Re: City of Grass Valley letter dated February 15th 2023 comments on the Final EIR

To: Ben Mossman, Rise Grass Valley, Inc.
From: Matthew Morales, Dudek
Subject: Idaho-Maryland Mine Projects – Additional Response to Comments
Date: April 14, 2023
cc: Jennifer Reed, Dudek
Attachment(s): A. Baseline Environmental Consulting Comments

Subject: Review of Idaho-Maryland Mine Project, Final Environmental Impact Report, SCH# 2020070378

SUBJECT: Additional Responses to Comments GRP 8-127 through -133

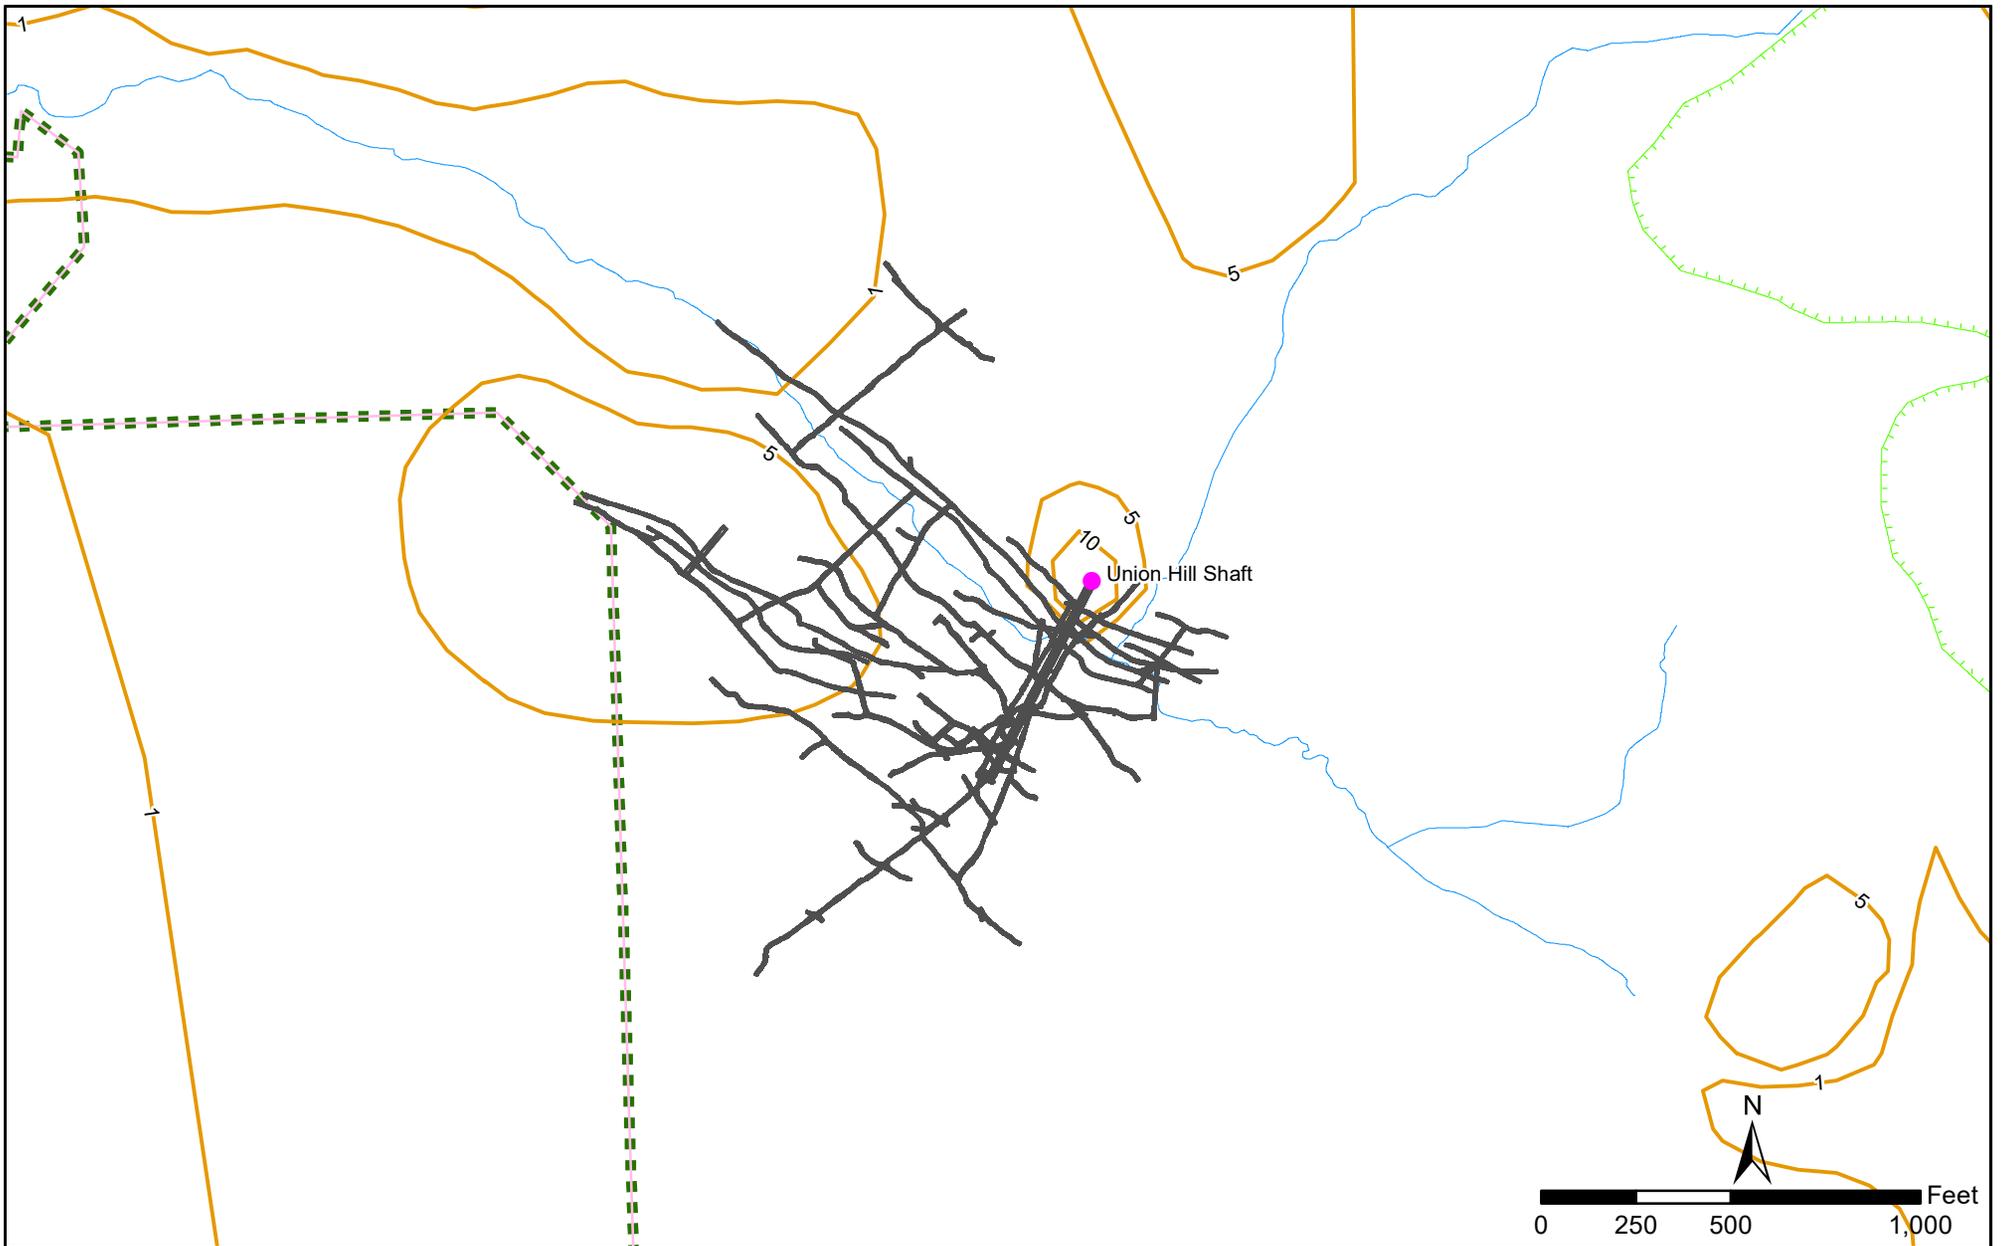
In response to my request for a figure showing a drawdown map for 1956, at the end of historic mine dewatering, the response directs to inserted Sheet 16 (FEIR Vol. VIII, Appendix L). This sheet is labeled as Monitoring Wells and Projected Drawdown after Initial Dewatering. This figure cannot represent the water levels from 1956 since the drawdown in the shallow aquifer in the

vicinity of the Union Hill Mine is a few feet, not the greater-than-20-feet indicated for 1956 (Figure 4-7 top).

Regarding Sheet 16, “Well Locations and Itasca Drawdown, Monitoring Wells & Projected Drawdown after Initial Dewatering” (FEIR Vol. VIII, Appendix L), this sheet illustrates predicted drawdown in the shallow aquifer in 1956, which can exceed 20 ft in areas. The 20-ft drawdown contour in the Union Hill Mine was shown south of well W1 on Sheet 16.
